Town of Medway
DESIGN REVIEW COMMITTEE
155 Village Street, Medway MA 02053
(508) 533-3291

DRC Meeting Minutes: June 04, 2018 Medway Public Library

Design Review for 9 Trotter Drive site plan for Converting Technical Services

PROJECT / SIGN TYPE: O'BRIEN & SONS SIGNS

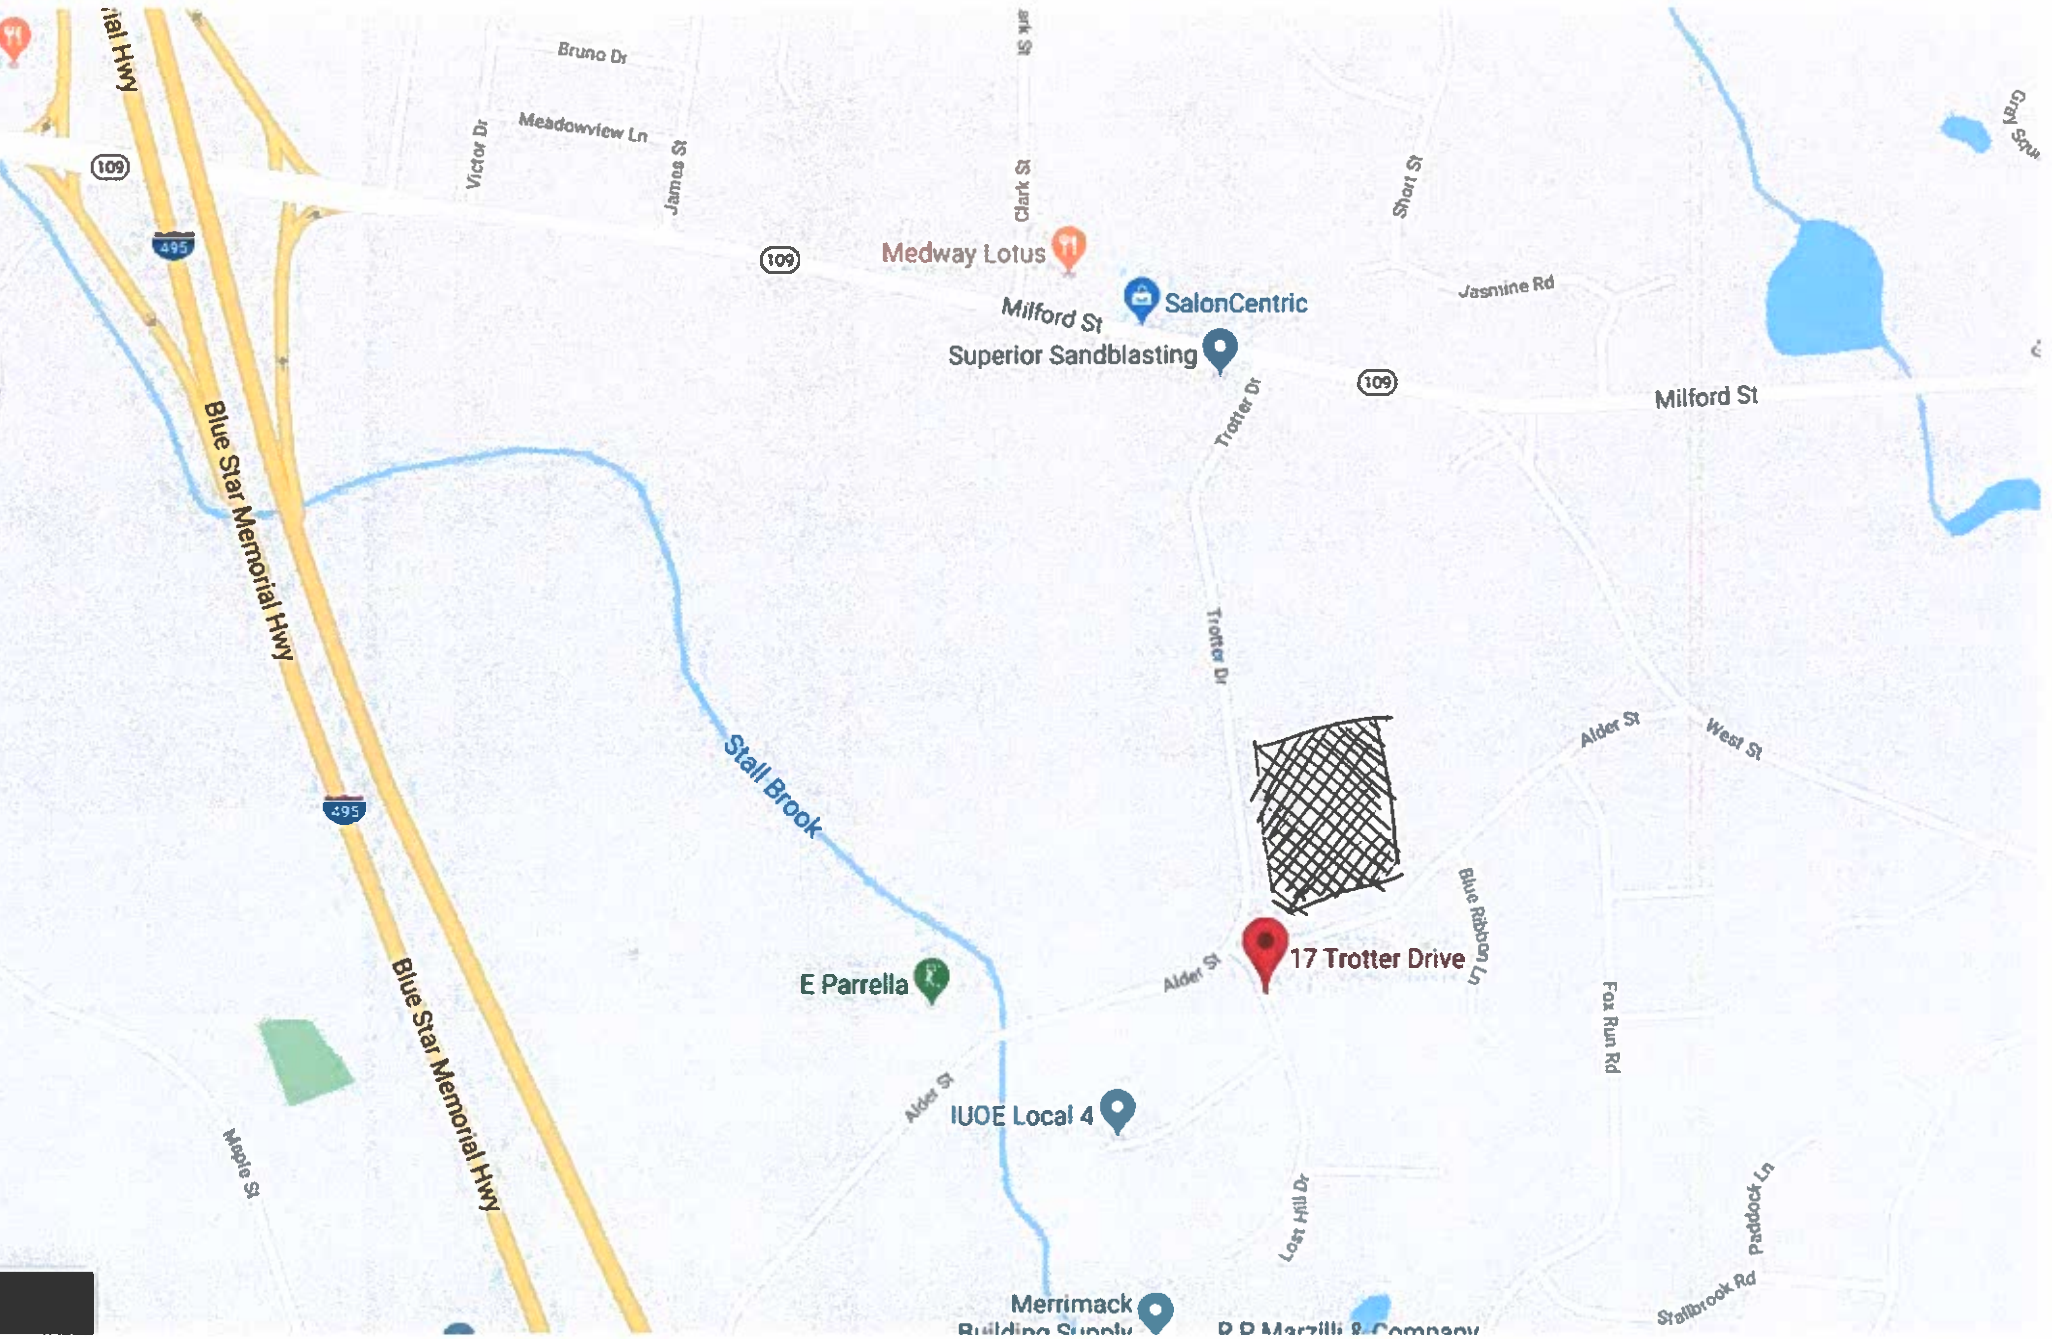
1. Very colorful (orange and blue) and contemporary feel, similar to the building itself
2. Landscaping is required around the base of the free-standing sign 3' in all directions. I emailed the applicant and sign company on 5/30 and asked if they could prepare a landscape plan to show you Monday night. Stay tuned!

PROPOSED LAYOUT
SITE PLAN

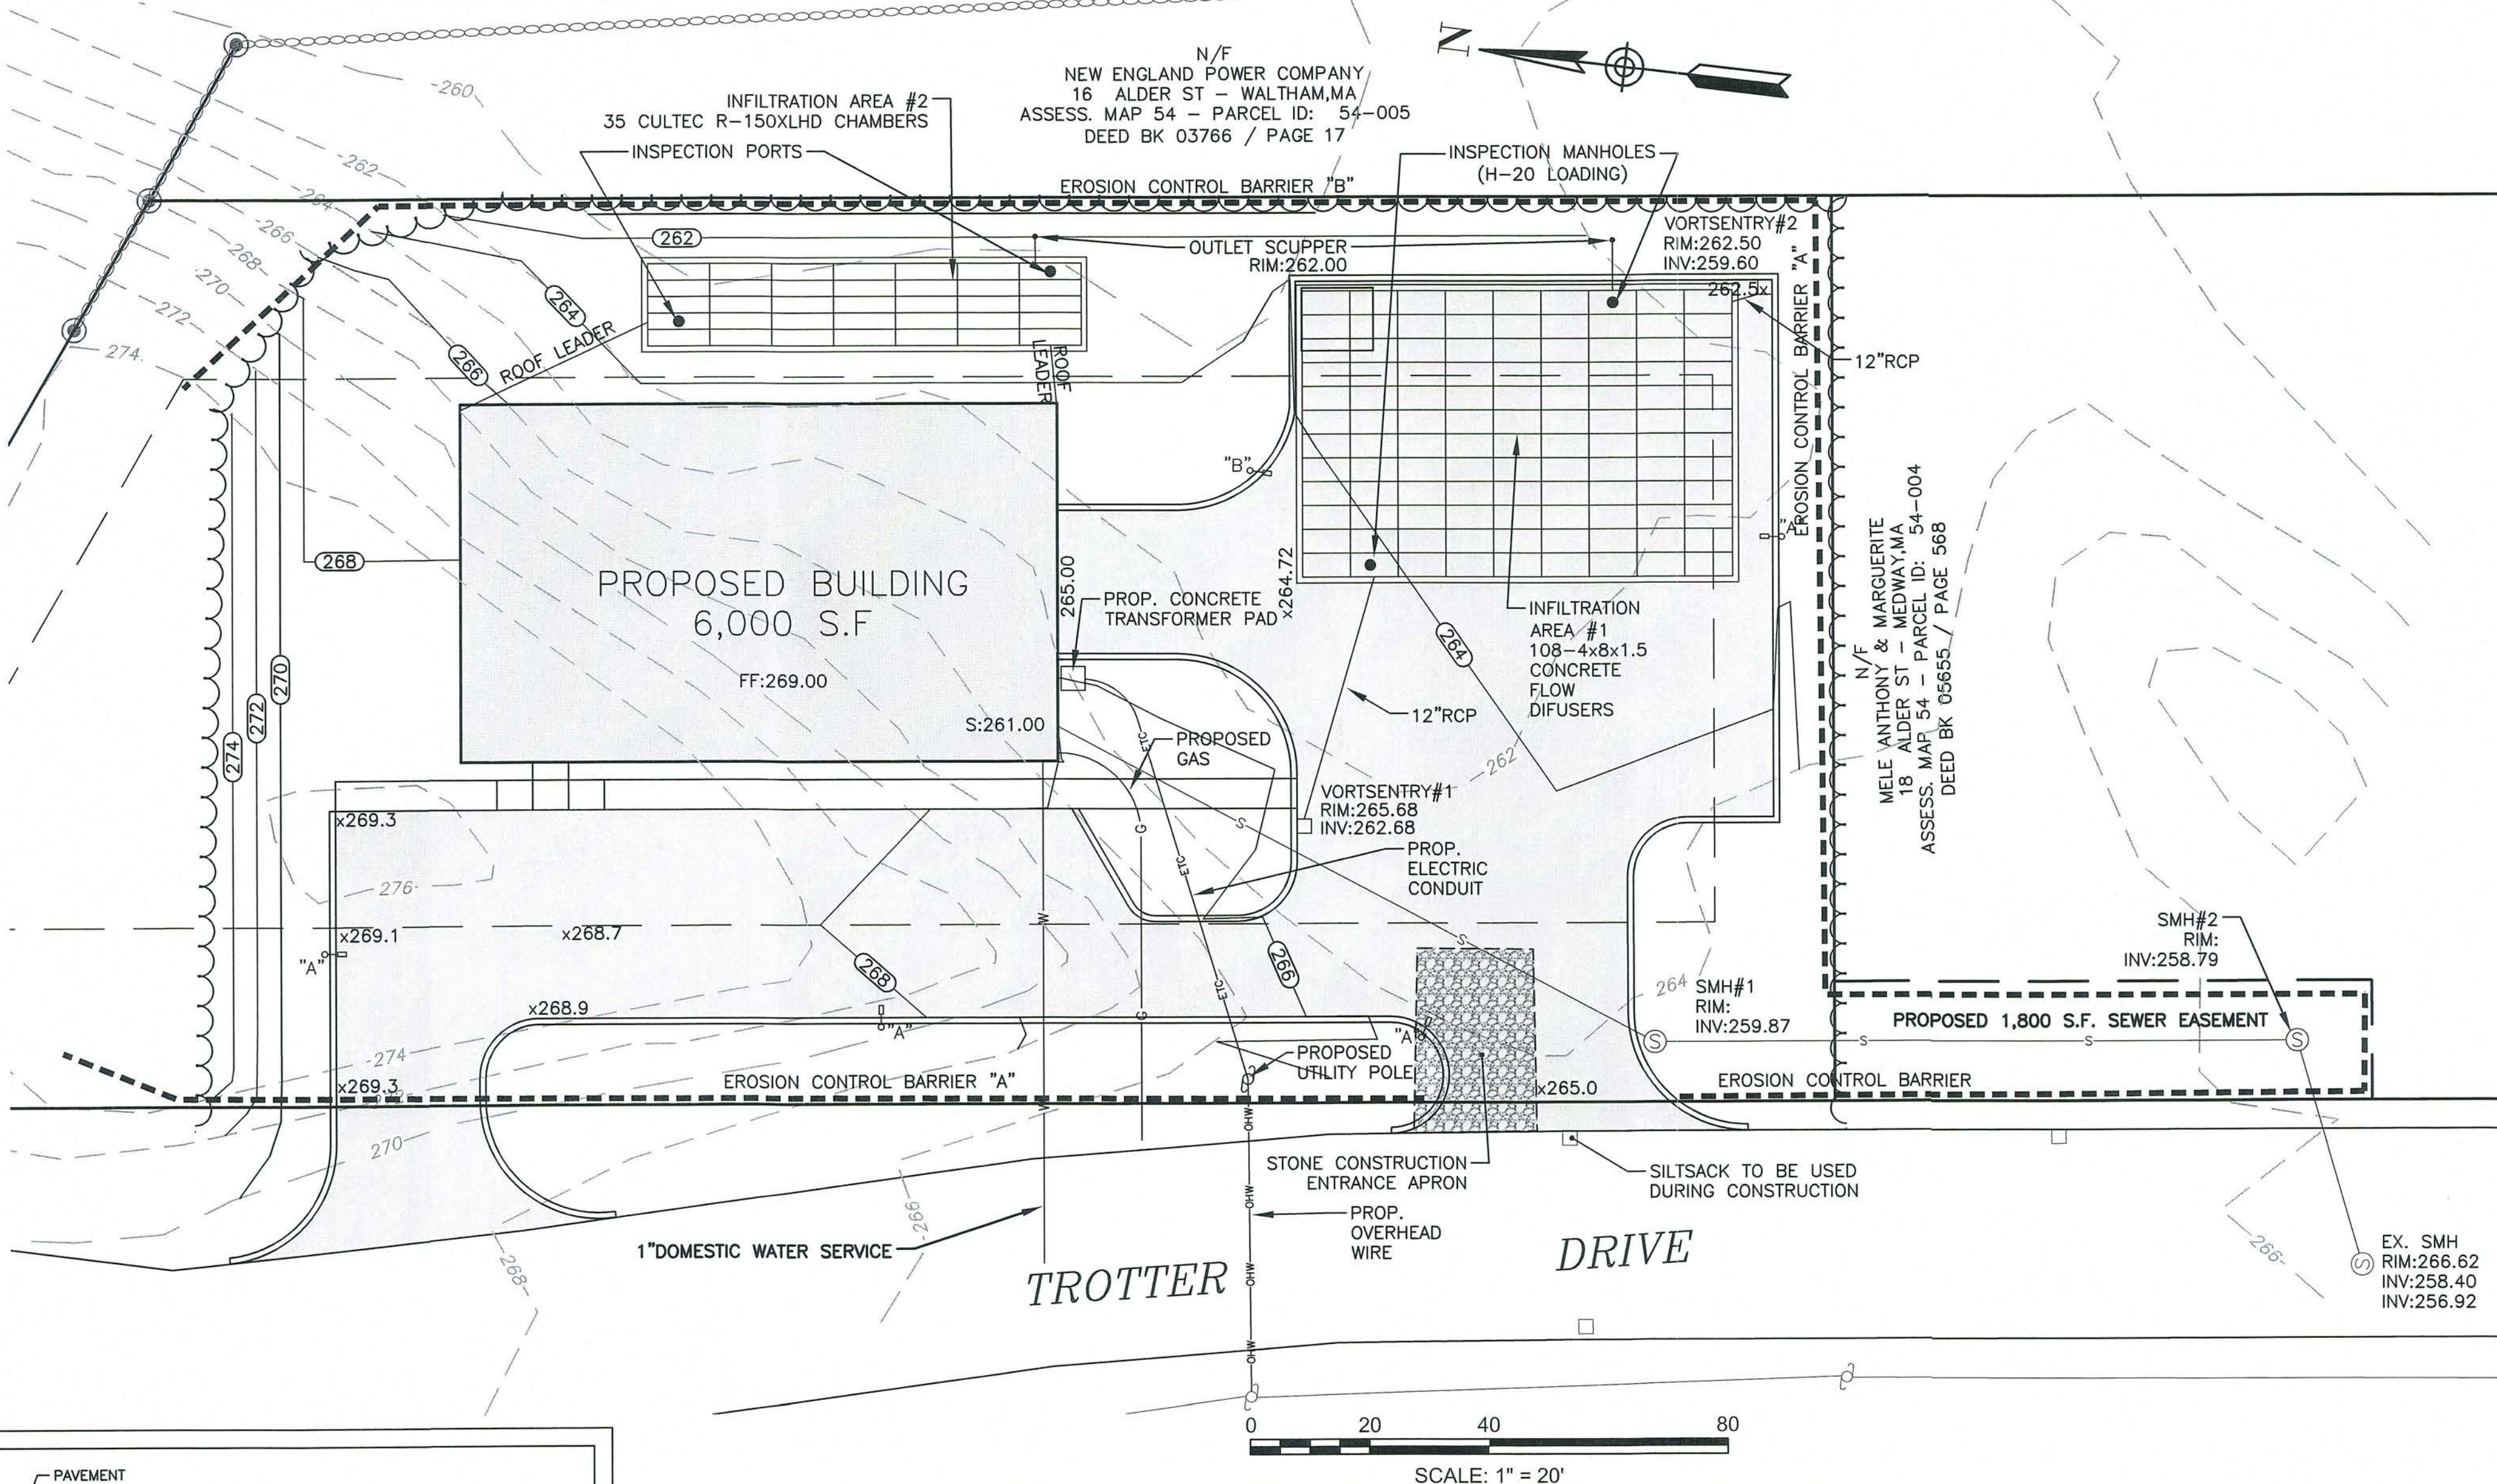
- ❖ Mr. Peter Bemis, Engineering Design Consultants, Inc. and John Younis, Priggen Steel attended the meeting to discuss this item.
- ❖ Mr. Bemis described the proposed project with the site plan and locus map. (See Attached) There's a driveway coming in on the south end of the site with one-way travel flow in the front of the building with exiting traffic going out the northern curb cut. The building will be close to the rear setback.

- ❖ 21 parking spaces are currently proposed and the parking lot will be graded to prevent stormwater run-off from entering Trotter Drive.
- ❖ Street trees are proposed as well as landscaping to screen the parking area from the adjacent parcel. A screened dumpster will be provided for refuse storage and disposal.
